SUBJECT: Response to Regulatory Comments on Closure Plan for CPP-59, Kerosene Tank Overflow - ERD-209-91

Response to EPA and IDHW Comments on CPP-59 Closure Plan

ERRATA SHEET FOR CPP-59 CLOSURE PLAN

Figure 9.
**SAMPLING LOCATIONS AT
LAND DISPOSAL UNIT CPP-50**

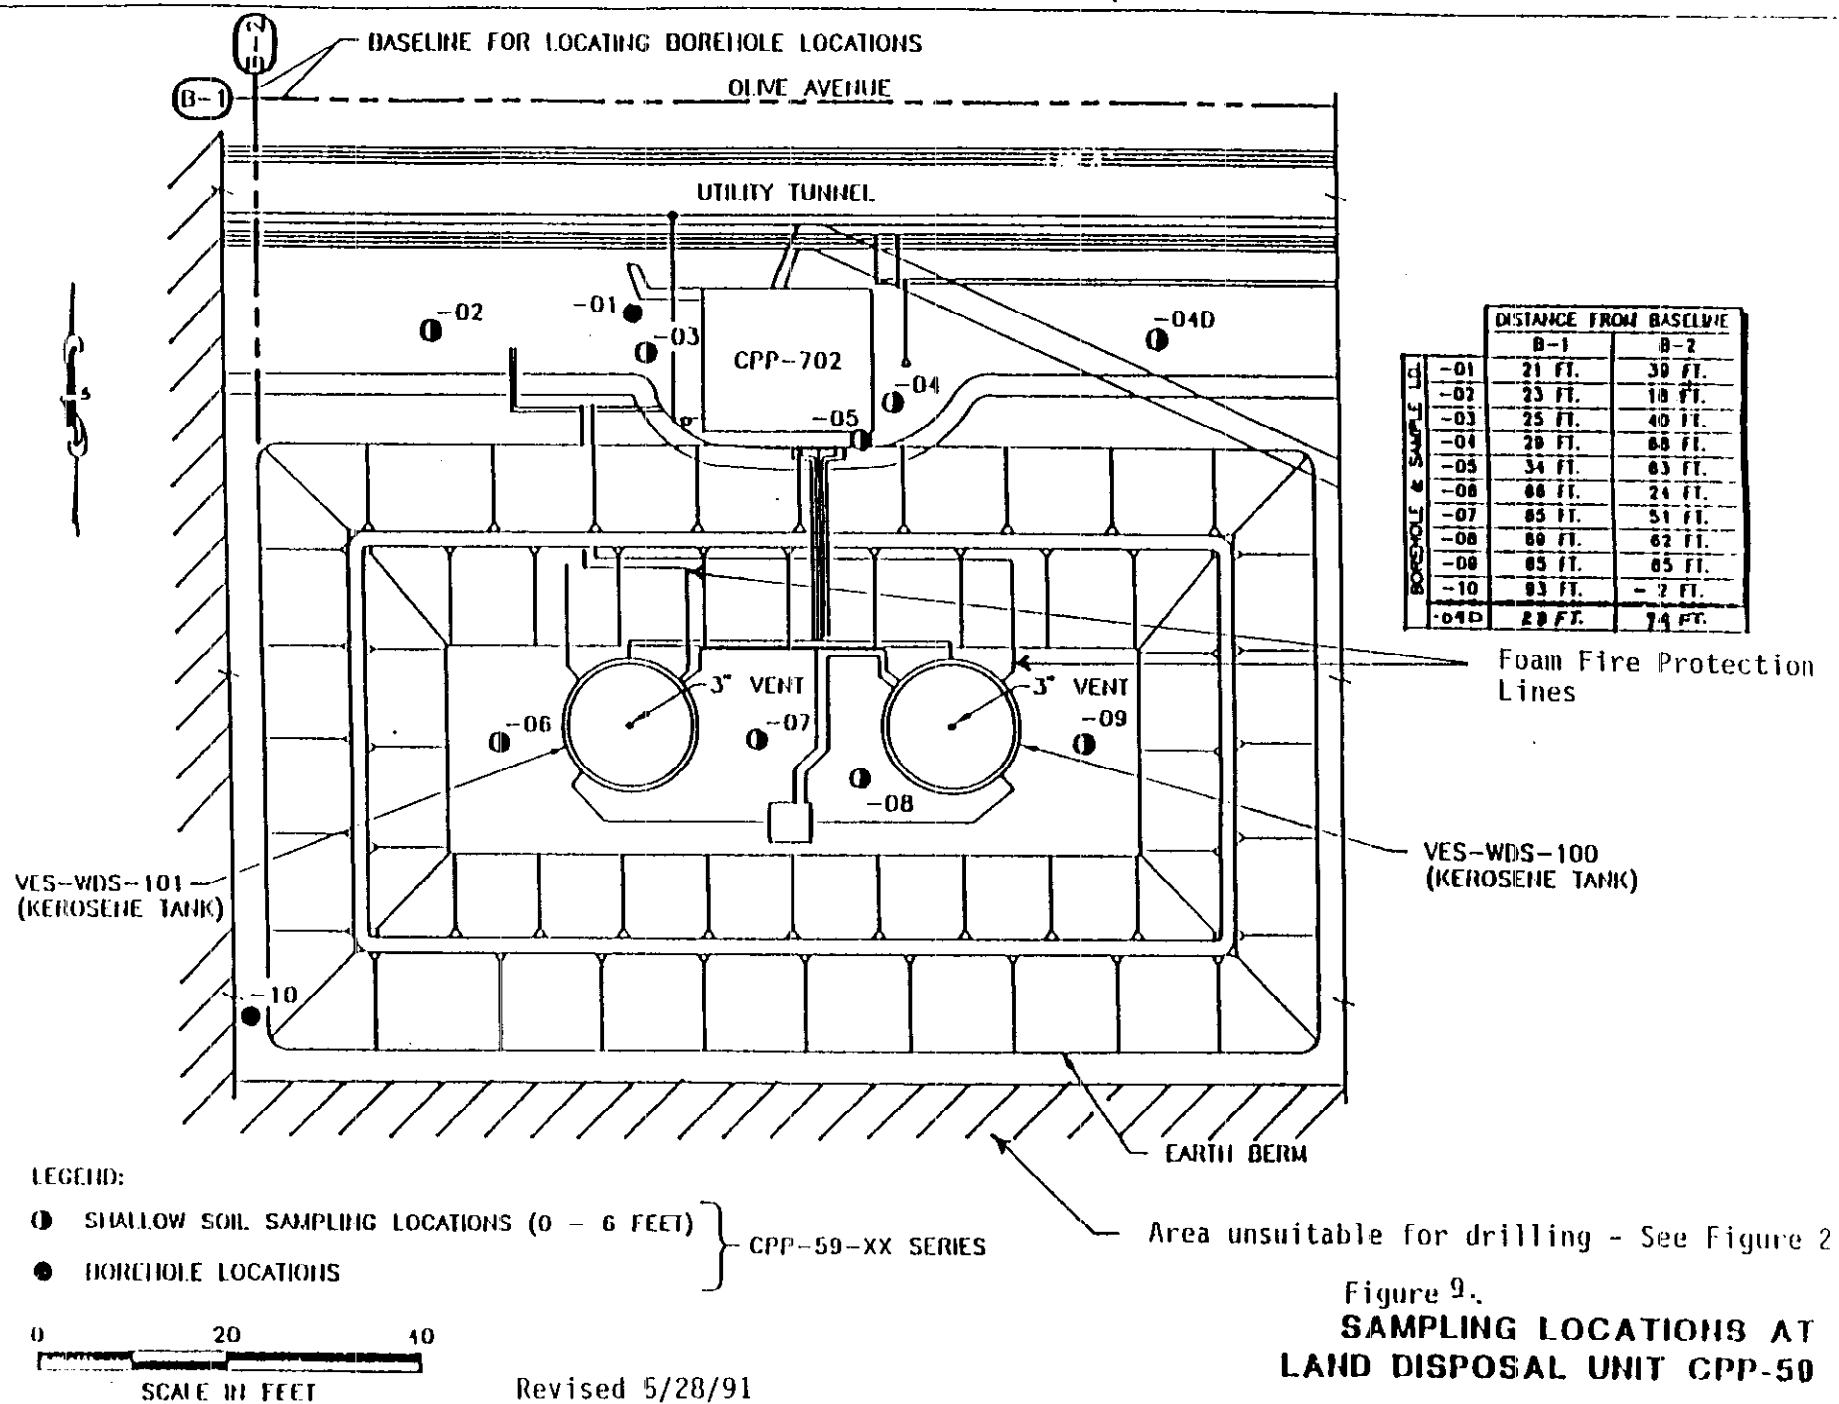
Section 1.1, page 5, first paragraph. It is stated that when the bulk storage tank (WDS-100) overflowed, the foam fire protection line on the tank filled with kerosene and subsequently drained out of a vent outside the bermed area. Where is the vent located? There is no indication on any of the maps or diagrams of the facility as to where the foam fire protection line or vent are located. There is no way to tell from any of the information provided in the Closure Plan whether or not soil sampling was done at the site of the spillage outside the secondary containment area.

Section 6.1.1, page 26, Sampling and Drilling It is stated that drilling at this unit was limited by the presence of overhead electrical units, building CPP-702, the kerosene tanks, the containment berm, and buried and surface pipelines. It is also stated that sampling locations were selected based on areas likely to be affected by the reported spills while avoiding physical obstacles. The sample locations shown on the map seem to bias the sampling to one area outside the bermed area. There are no shallow samples on three sides of the secondary containment area. No surface elevations are noted on the map so there is no way of knowing if the samples were taken at a higher elevation than the bermed area or an area above where any spilled kerosene would accumulate. Additionally, since the foam fire line is not indicated on the map, there is no way to ascertain whether or not samples were taken near the vent on the line where the kerosene leaked out. Please provide surface elevations of samples taken as well as the location of the foam fire protection line.

Page 27, Figure 9, replace with revised Figure 9 (Attached).

The location of the vent for the foam fire protection line will added to Figure 9 (Revised 5/28/91). For information, the volume of this line is estimated to be less than 13 gallons.

The sampling locations outside the berm were intentionally biased to the area where releases were thought to have occurred. The releases occurred as a result of the overflow from the vent on the foam fire suppression line and potentially in the loading and unloading area near the northwest corner of building CPP-702. The containment berm is elevated approximately four feet above the surrounding ground surface. The surface elevation outside the bermed area generally slopes in a northerly direction, toward Olive Avenue. The location of the foam fire protection line will be included on Figure 9.
